ADDENDUM # 1 Questions and Clarifications

**Transit Center Renovation
IFB #FED2019-11 through IFB#FED2019-11.05**

**Greater Peoria Mass Transit District (GPMTD/CityLink)
Transit Center Renovation**

Addendum 01

A7.2

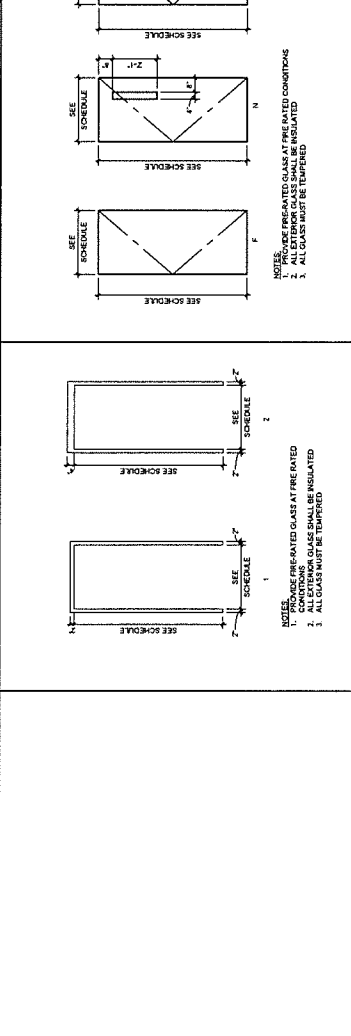
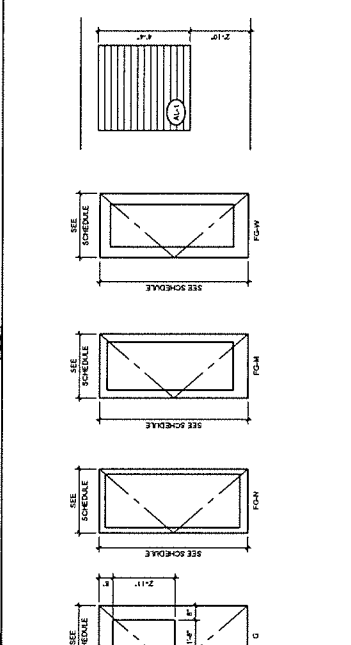
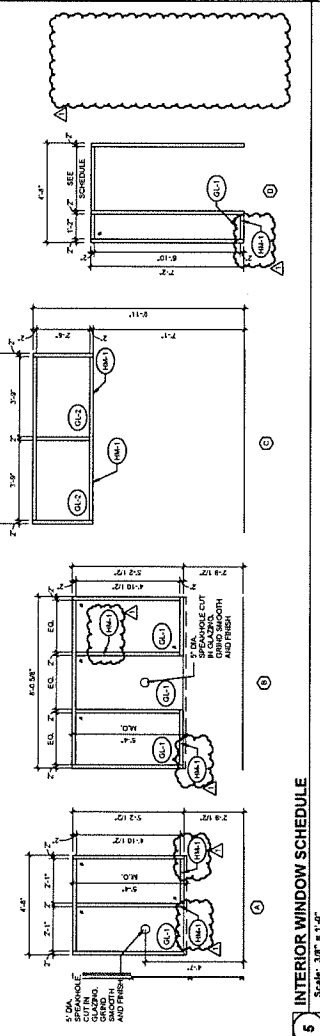
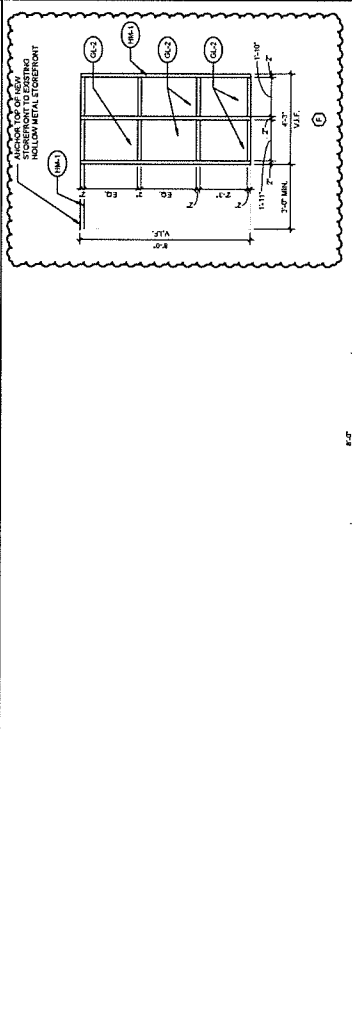
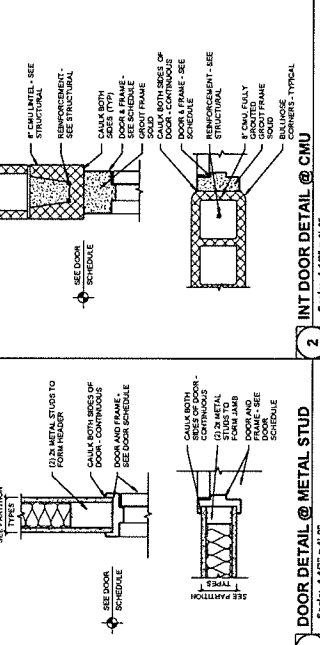
1. Clarification: New interior windows in CMU will be centered within the wall, with bullnose around edges.
2. DELETE Window type E in its entirety.
3. Reference Drawing 5/A7.2: All borrowed lite frames to be hollow metal.
4. ADD Window Type F, refer to revised sheet A7.2 (re-issue).

A8.2

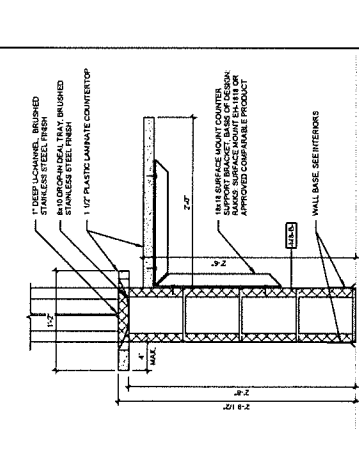
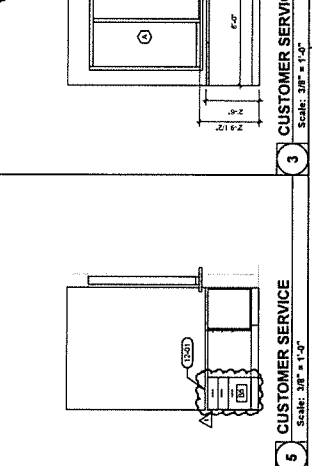
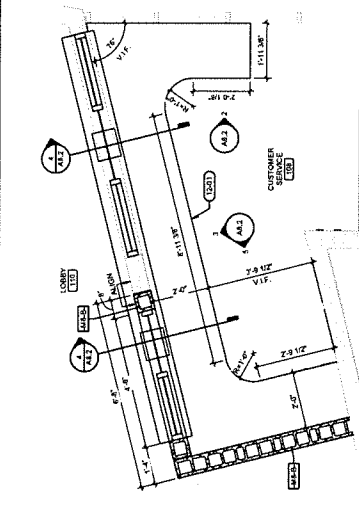
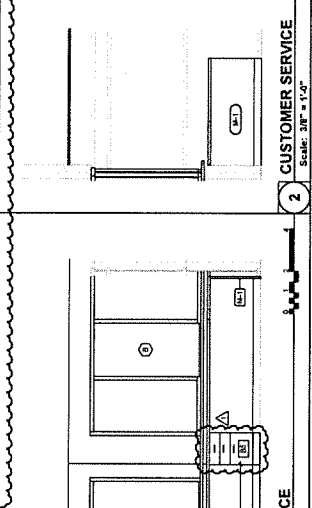
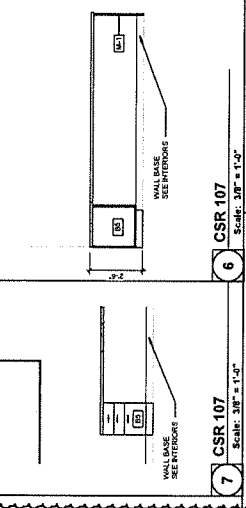
1. See attached A8.2 (reissue) for revised plans.

11.1

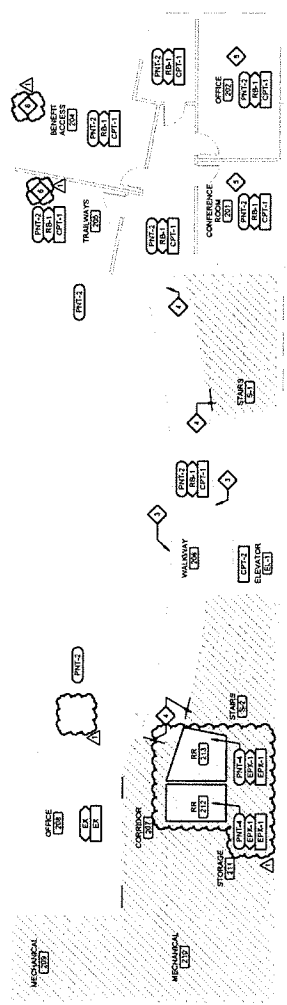
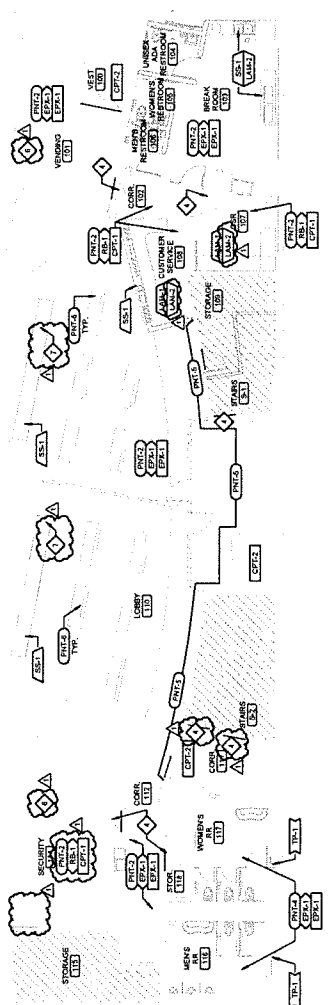
1. See attached I1.1 (reissue) for revised finish plans.

E6.2

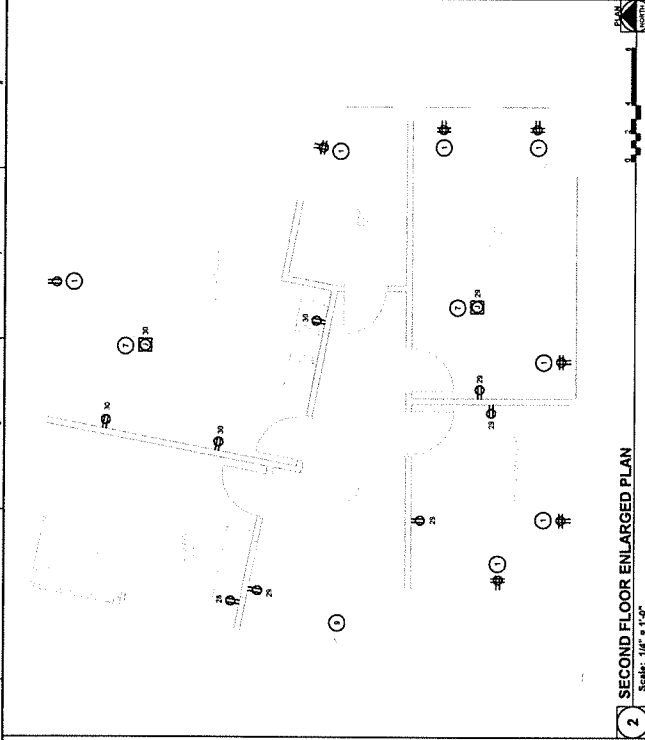
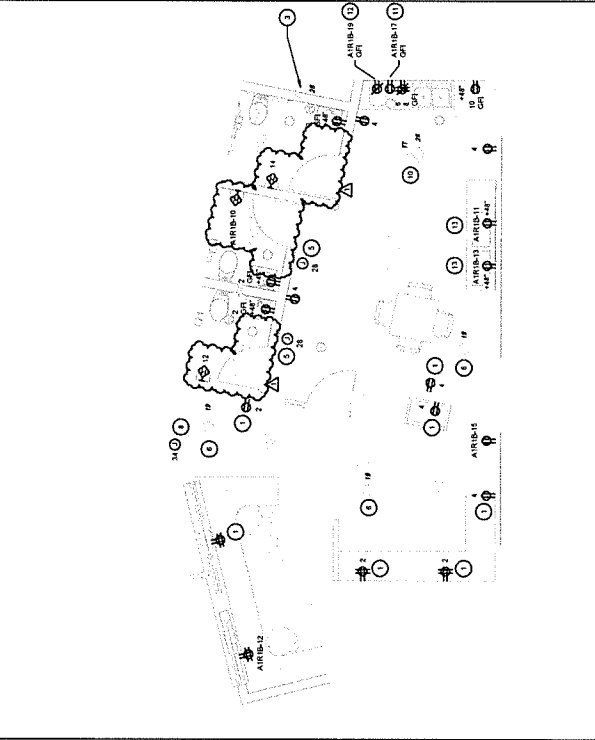
1. REVISE location of electric hand dryers as shown on sheet E6.2 (re-issue).
2. REVISE location of electric hand dryer as shown as shown on sheet E6.2 (re-issue).
